DEPARTMENT OF JUSTICE
NATURAL RESOURCE DAMAGE PROGRAM

Re: State of Montana Natural Resource Damage Program Comments on Future EPA Decisions that Could Impact Cost and Implementability of Constructing the Blacktail Creek Remedial Action within the BPSOU CD

Attachment A

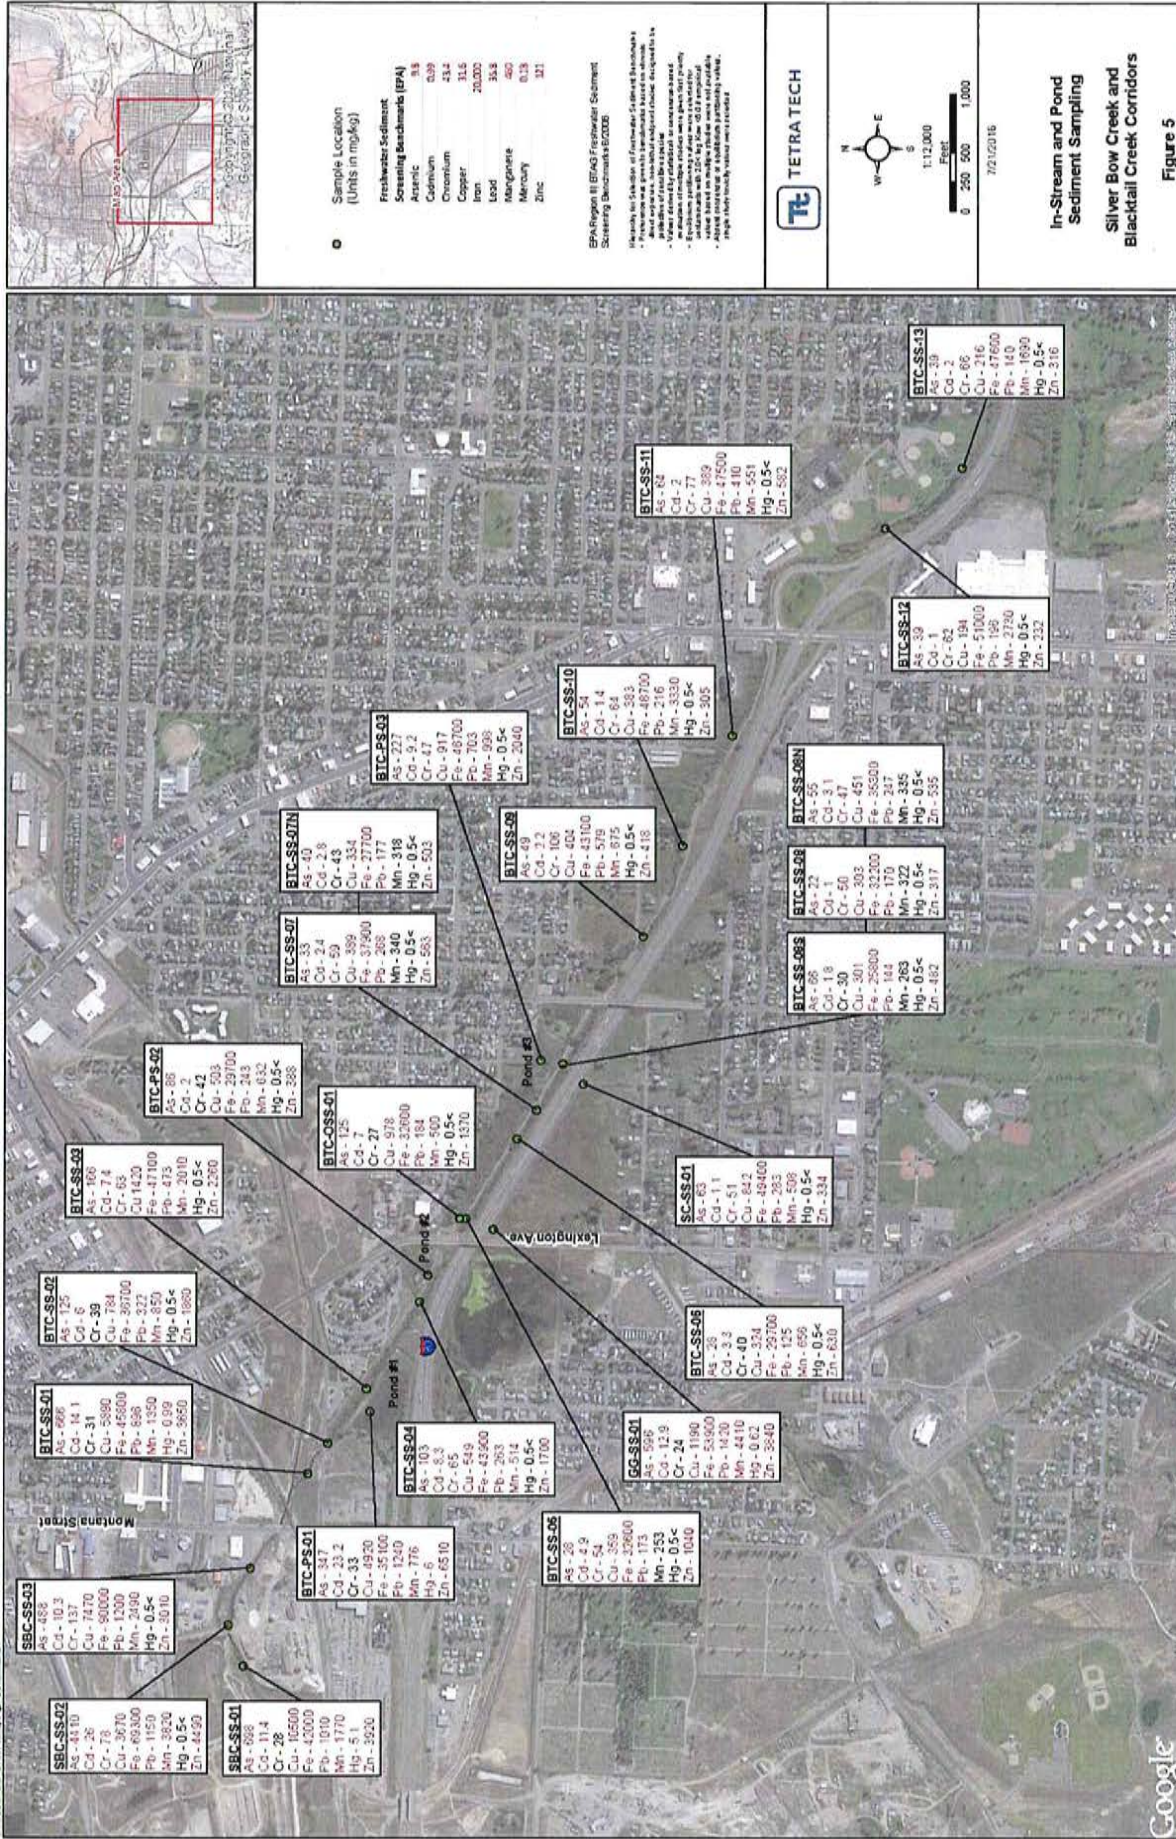
NRDP and DEQ have documented and quantified over the last 15 years that instream sediments of Blacktail Creek within BPSOU and directly upstream of the BTC Site are contaminated with historic mine wastes. The State has collected this data to monitor the progress of the remedy and restoration of the Streamside Tailings Operable Unit (SSTOU) and while NRDP was investigating the contamination at the Blacktail Creek Site in 2015 - 2017. The most robust of these instream sediment quality sampling efforts on Blacktail Creek was performed by NRDP in 2016 (Attachment A).

There are instream sediment samples in Blacktail Creek in the West Side Soils Operable Unit (WSSOU) upstream of the BTC Site that exceed the BPSOU CD Surface Water Management Plan Table 8-1 for copper by 3 times (451 mg/kg) and zinc (Attachment A., Table 1). This contamination is part of the WSSOU and not the BPSOU.

Constructing a downstream project that involves removing the entire creek bed, banks, and floodplain before upstream projects that involve removing wastes from the entire floodplain on a fluvial system such as this poses a significant risk of downstream recontamination. There are instream sediment samples in the BTC Site that exceed the BPSOU CD Surface Water Management Plan removal criteria for copper by 39 times (5,890 mg/kg) and zinc by 14 times (6,510 mg/kg) (Attachment A, and Table 1).

Figure BTC-1
Blacktail Creek
Remedial Action Plan

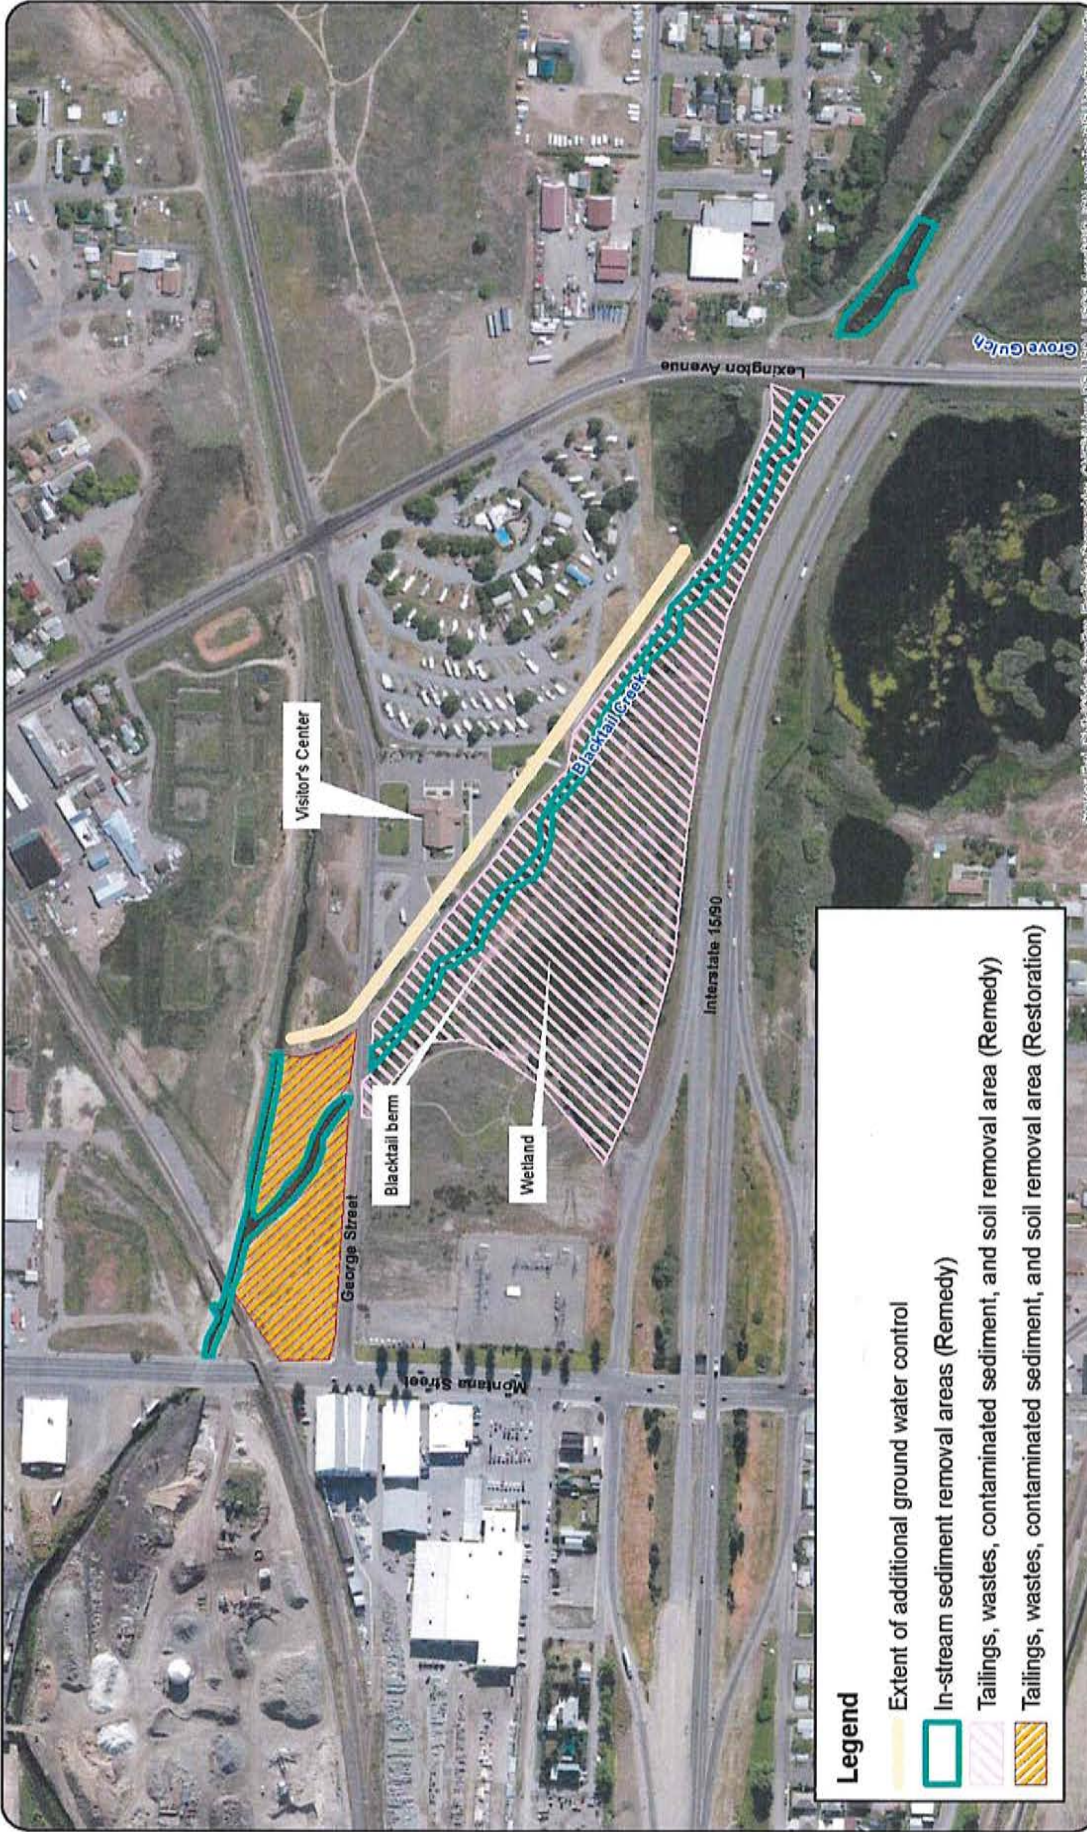
Recontamination from upstream projects is likely regardless of when the BTC Site construction occurs. Instream sediment contamination from the BTC Site will transport to the BRW Site every year regardless of when construction occurs (Attachment B). Also, this situation should not preclude the full utilization of the Surface Water Management Plan instream sediment performance triggers for evaluating the effectiveness of BP-AR groundwater capture system specifically at the BRW Site (Table 1).

The BTC groundwater capture system that BP-AR is required to construct should be fully functional prior to the State's construction of the BTC Riparian Actions (Attachment B). If the BTC Riparian Actions are constructed prior to this groundwater control, contaminated groundwater could recontaminate the instream sediments. BP-AR has recently acknowledged this sequencing necessity in its latest schedule, as is required by Exhibit 1 to Appendix D of the BPSOU CD. We thought it prudent to restate it here.

Figure BG-1
Buffalo Gulch
Remedial Action Plan

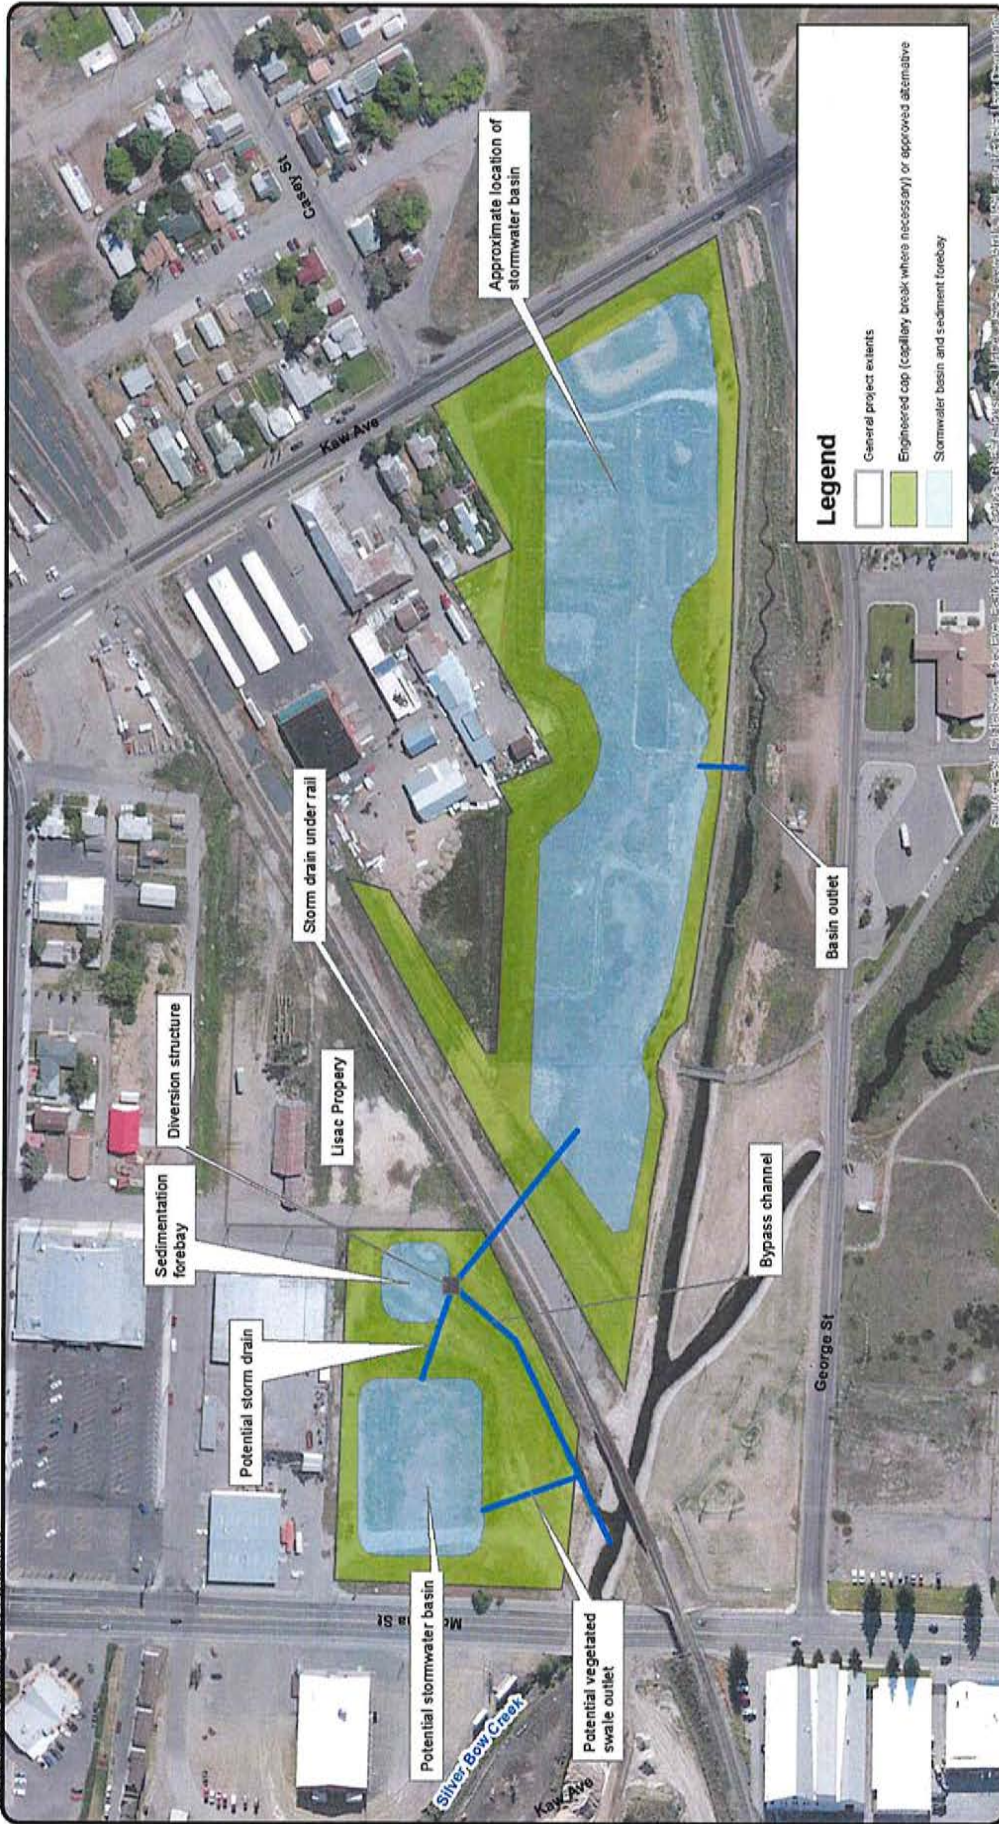
It is clear from the attached figures that the Digging East Stormwater Basin (DESB) (Attachment D) and Buffalo Gulch Stormwater Basin (Attachment C) will both need to be constructed and functioning prior to the State's BTC Riparian Actions work. Without these capture and treatment systems in place, contaminated sediments would continue to be transported by Silver Bow Creek above the confluence to the BTC Site, specifically the confluence area. Clearly, as in other cases,

these upstream historic mine waste contaminant sources and pathways need to be addressed prior to implementation of downstream waste removal projects.
